ADDENDUM NO. 30 - Contract Drawing C.1

**CONTRACT 876-HP
GEOMEMBRANE CAPPING AND
GAS COLLECTION SYSTEM
PELHAM BAY LANDFILL REMEDIATION
BOROUGH OF THE BRONX
NEW YORK**

Bid Form - Contract No. 876-HP - Revised 5/25/94

ADDENDUM NO. 33 - Contract Drawing C.9

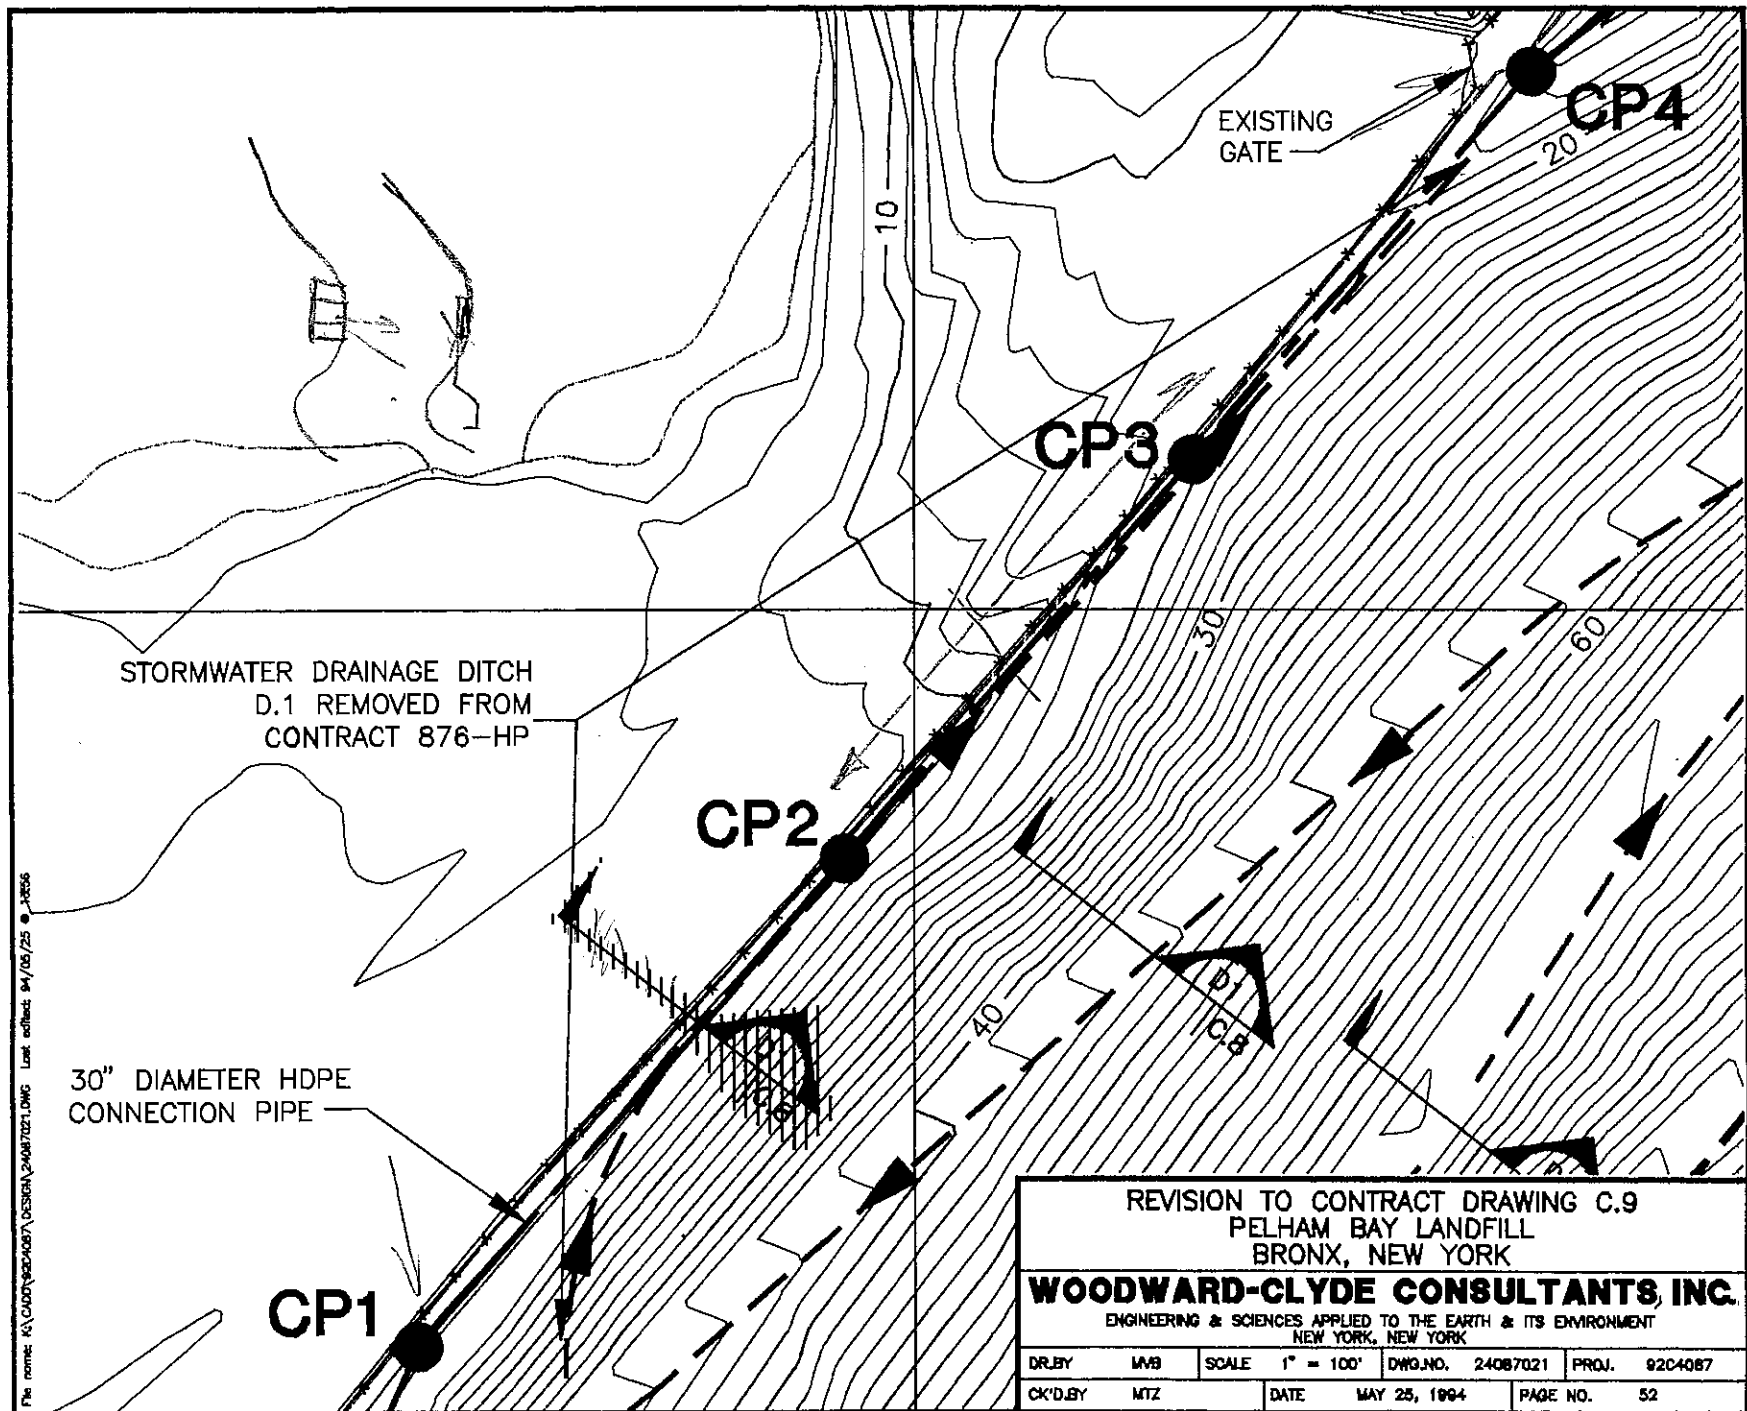
1. Revise Contract Drawing C.9 as described below and shown on the drawing attached on the following page.
 - A. Remove the stormwater drainage ditch shown adjacent to Pelham Bridge Road along the northwest boundary of the landfill, extending from manhole CP1 to CP4.

REVISION TO CONTRACT DRAWING C.16
PELHAM BAY LANDFILL, BRONX, NEW YORK

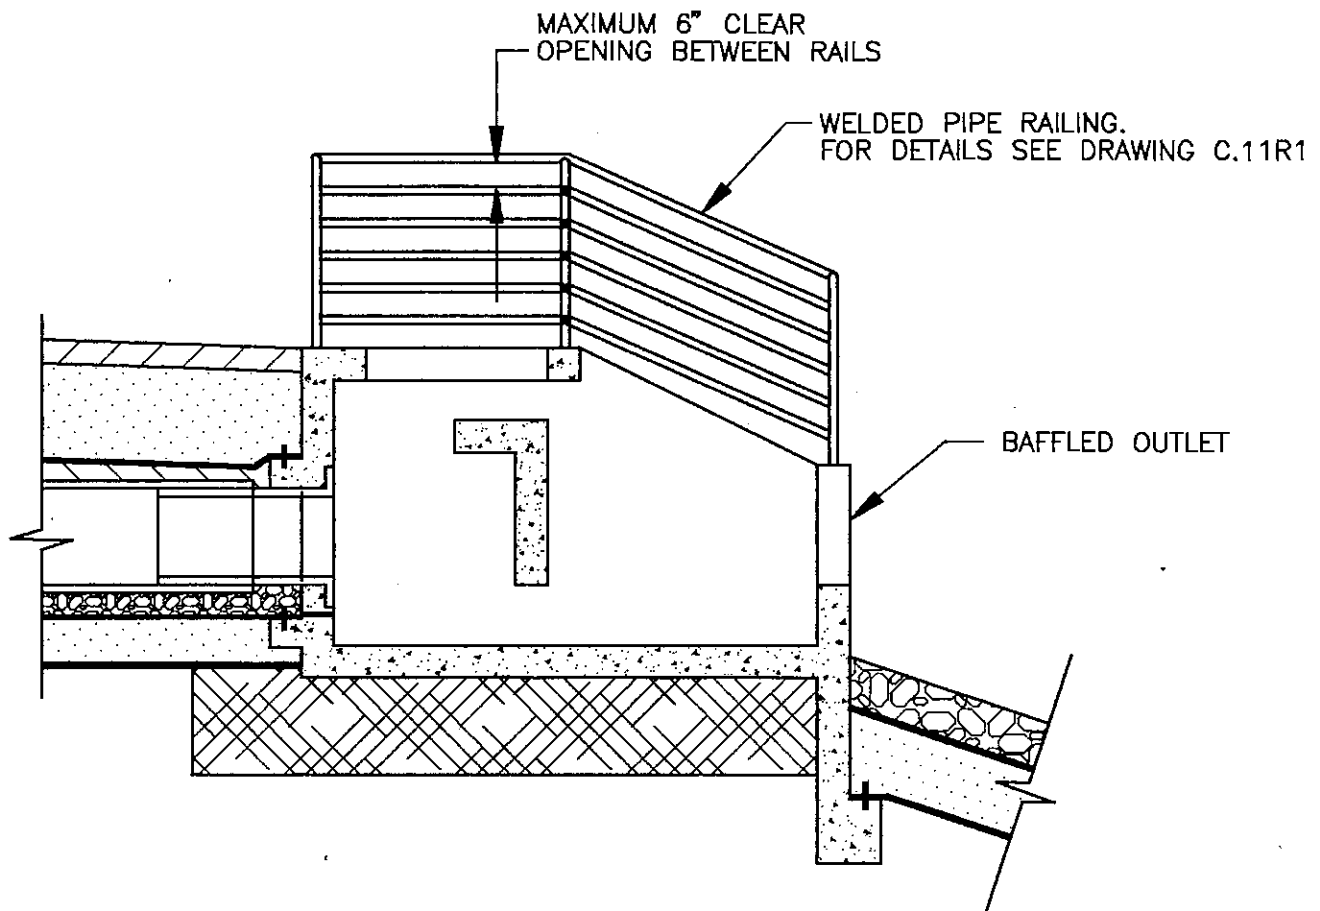
1. Replace the Welded Pipe Railing details for Baffled Outlets BO1, BO2, BO3, and BO4 with the revised version, attached on the following page.

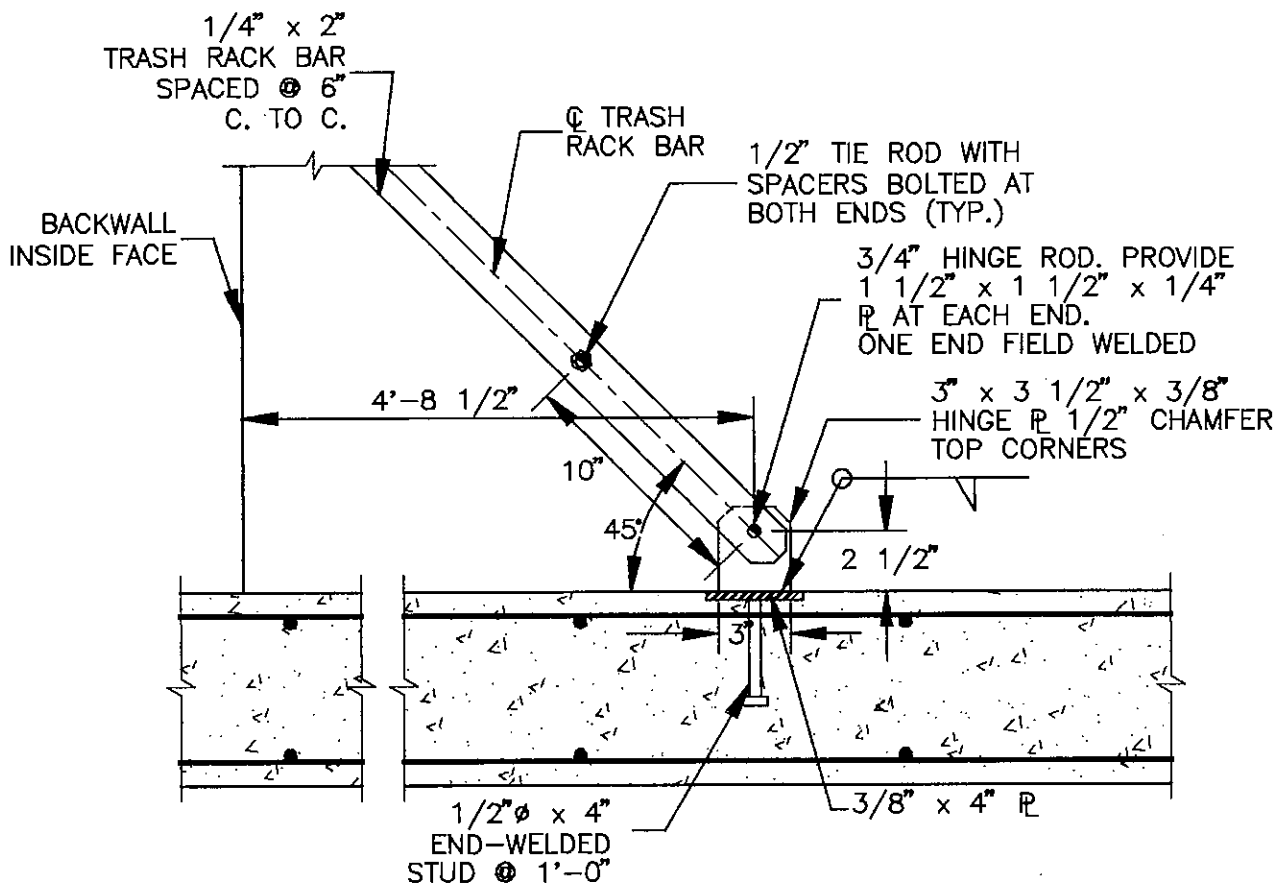
1. Replace Detail 3 and Detail 4 with the revised versions, attached on the following pages.
2. Delete Lighting Plan - 5 from Contract 876-HP.

ADDENDUM NO. 39 - Contract Drawing C.18

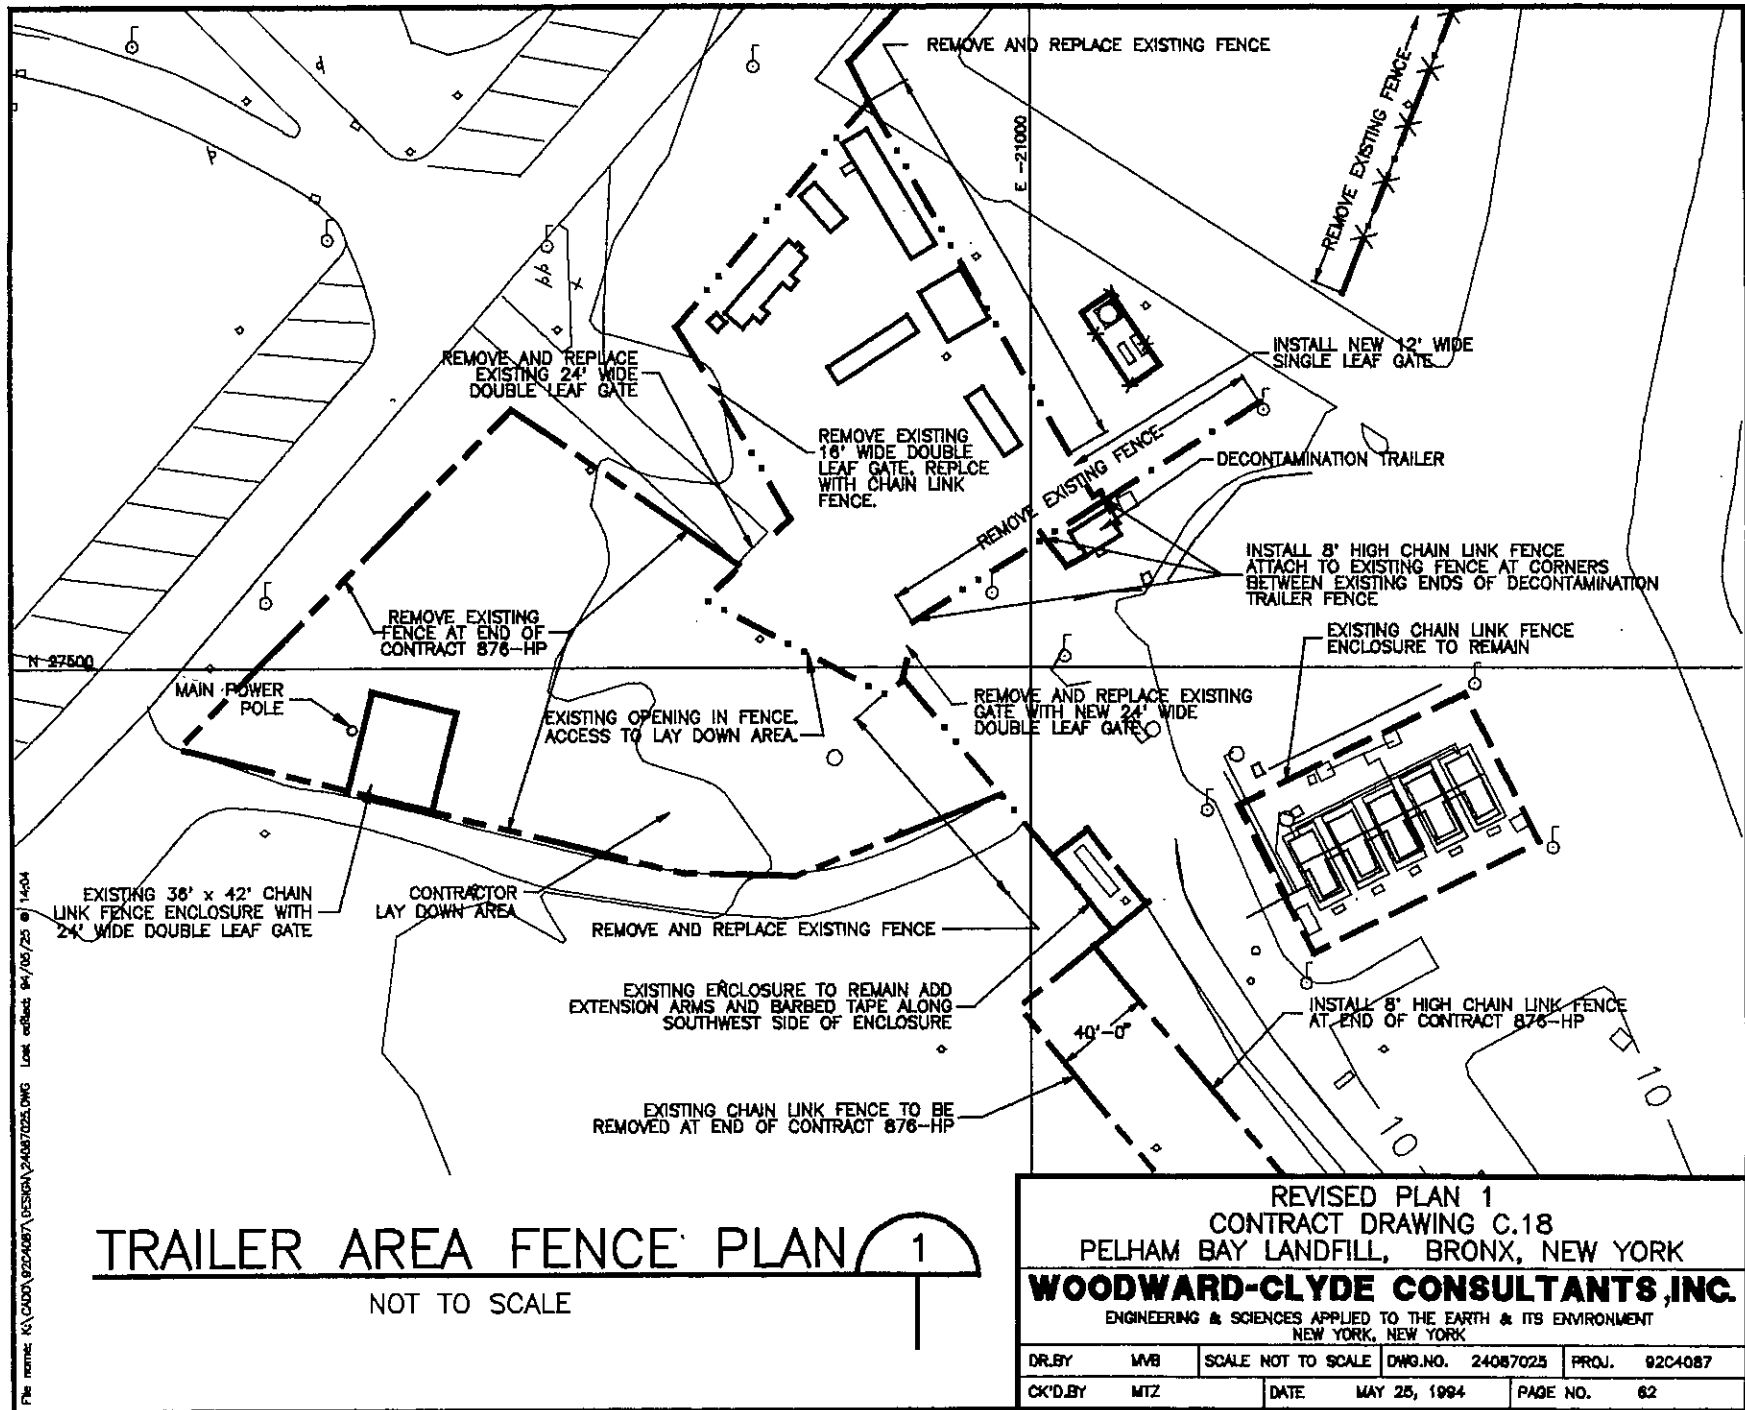
1. Replace Trailer Area Fence Plan with the revised version, attached on the following page. Revision made to this Plan is described below:
 - A. Existing fence condition around the contractor's lay-down area has been modified.
